Property:	27-31 Belmore Street, Burwood
DA No:	89/2012
Proposal:	Mixed Use Development: 3 storey podium and 3 residential towers containing 210 residential units, 8,616m ² of commercial/retail space, with 6 basement parking levels (revised)
Owner:	Goldfield Australia Pty Ltd
Applicant:	Goldfield Investment Pty Ltd

ADDENDUM REPORT

This report forms an addendum to the Development Assessment Report considered by the Sydney East Joint Regional Planning Panel on 13 December, 2012 in relation to DA 89/2012 for mixed use development at 27-31 Belmore Street, Burwood. That report as well as this addendum has been prepared by Planning Ingenuity, independent consultant town planners.

Figure 2: Level 4 excerpt from Issue G Plans including reduced podium (to south-east of Building C)

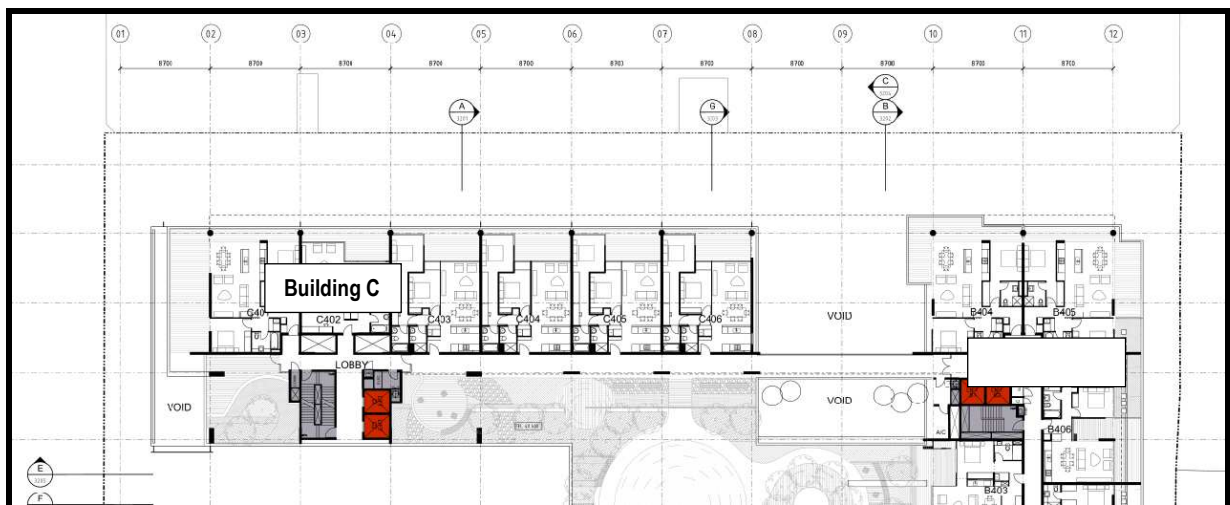
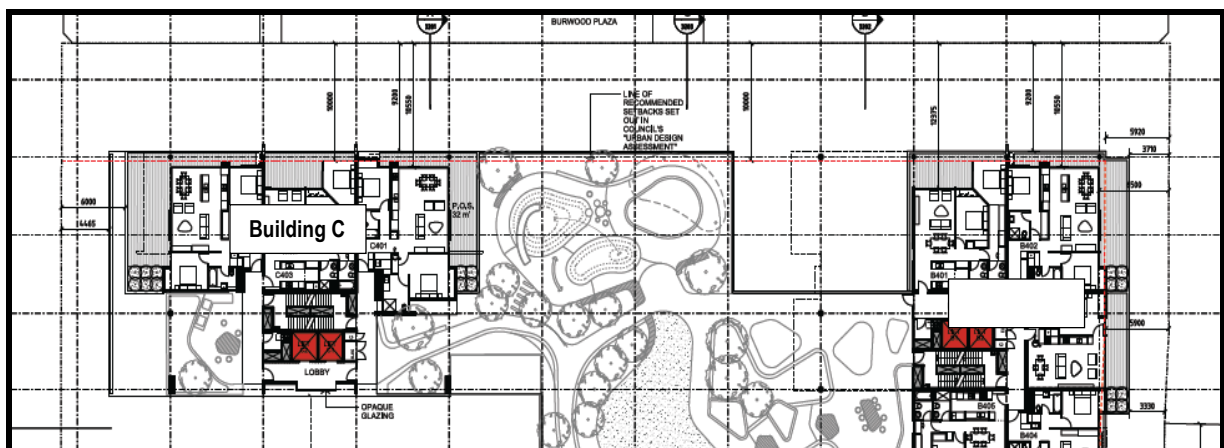
The amended scheme (a combination of Plan Issues F, G and H) generally follows the recommended design changes by increasing the "gap" between Towers B and C, albeit slightly varying the affected grids as a result of the fundamental changes to massing of the towers. Based on the sun eye diagrams and daylight access studies provided, it is considered that the primary intentions or the requested design changes have been met.

Figures 1-4 below (and Solar Access/Sun Eye Diagrams included at Annexure B) illustrate the changes that have occurred to Towers B and C to improve solar access to No. 33-35 Belmore Road. These modifications can be summarised as follows:

- Removing 3 units within Tower C to Level 4 between grids 05 and 08
- Removing 5 units within Tower C to Level 5 between grids 05 and 10;
- Relocating 1 unit within Tower B between grid 09 and 10 along the northern elevation;
- Reducing the area of podium to Level 4 and the retail space to level 3 by approximately 30m² between grids 05 and 06 and grids G and H.
